# Work Order ID 74328

Item Name: .Crosstube Aft

DRAWING NO. D212-664-241	TITLE CROSSTUBE ASSY (205/212 HI AFT)	REV. D	DART AEROSPACE LTD ENGINEERING ORDER		D.E.O. NO. D212-664-241-D-1	SHEET NO. SHEET 1 OF 2	SCALE NTS
DRAWN	CHECKED		MFG. APPR.		APPROVED	DE APPR.	
DATE 11.04.07	DATE 11.04.11		DATE 11.04.12		DATE 11/04/12	DATE 11.04.12

DRAWING NO. D212-664-241	TITLE CROSSTUBE ASS'Y (205/212 HI AFT)	REV. D	<b>DART AEROSPACE LTD ENGINEERING ORDER</b>		D.E.O. NO. D212-664-241-D-2	SHEET NO. SHEET 1 OF 1	SCALE NTS
DRAWN 97	CHECKED ASS	MFG. APPR. 8	APPROVED MD		DE APPR. H		
DATE 11.07.15	DATE 11.07.20	DATE 11.07.21	DATE 11/27/21		DATE 11-07-21

D212-664-241/-241B  
ASSEMBLY DETAIL

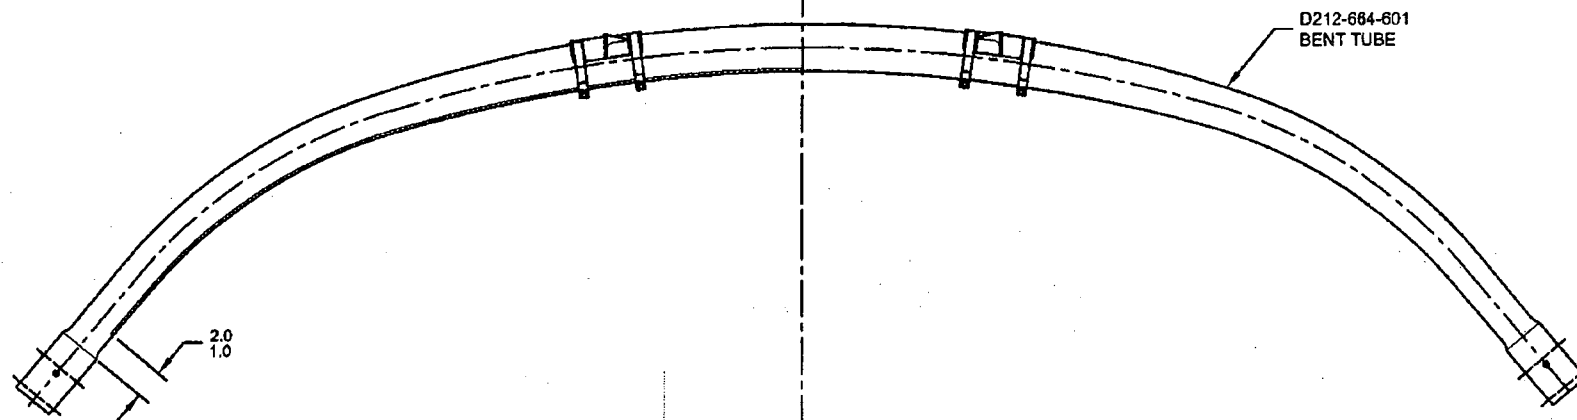
ADD AN INSPECTION WINDOW TO UNDERSIDE OF CROSSTUBE.

NOTES 2 OF SHEET 1 IS AMENDED AS FOLLOWS:

IS:WAS:

MASK AREA PRIOR TO PAINTING,  
REMOVE MASKING AFTER PAINT  
AND APPLY CLEAR COAT

- 2) FINISH: CHEMICAL CONVERSION COAT PER DART QSI 005 4.1  
PRIME INSIDE AND OUTSIDE PER DART QSI 005 4.2  
MASK UNDERSIDE OF CROSSTUBE AS SHOWN (HATCHED AREA) AND  
PAINT OUTSIDE PER DART QSI 005 4.2  
REMOVE MASKING AND APPLY CLEAR COAT

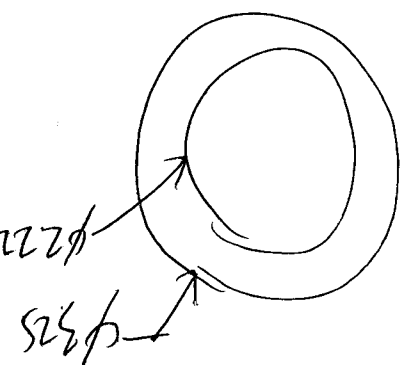
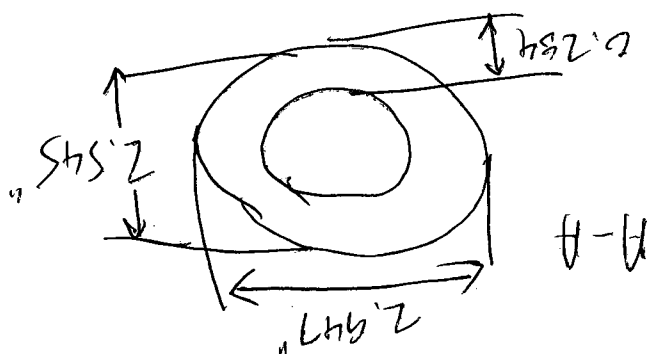
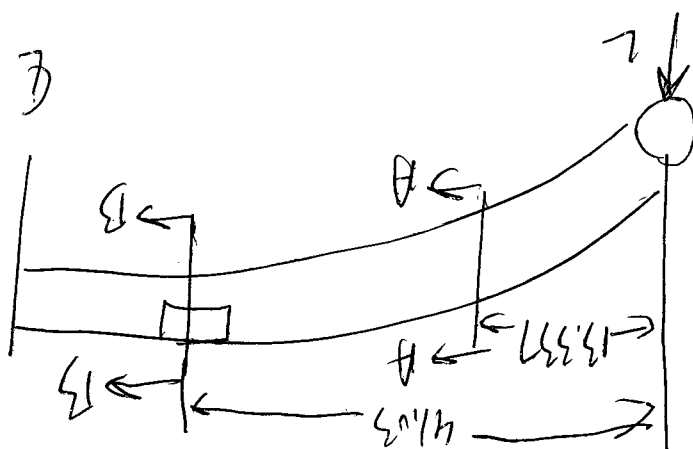
(A)	10 pieces	Comments
		7.6% crushing
(B)	10 pieces	
		7.3% crushing

Tube will fail at support before area of high.  
 crushing is acceptable  $\phi 11.11, 28$

$$M.S. = \frac{15,563}{11,454} - 1 = 0.35$$

$$B-B \quad P = M_c / I = 41.03 \times L \times 3.25 = 15,563 \times L$$

$$A-A \quad P = M_c / I = 13.337 \times L \times 2.545 = 11,454 \times L$$
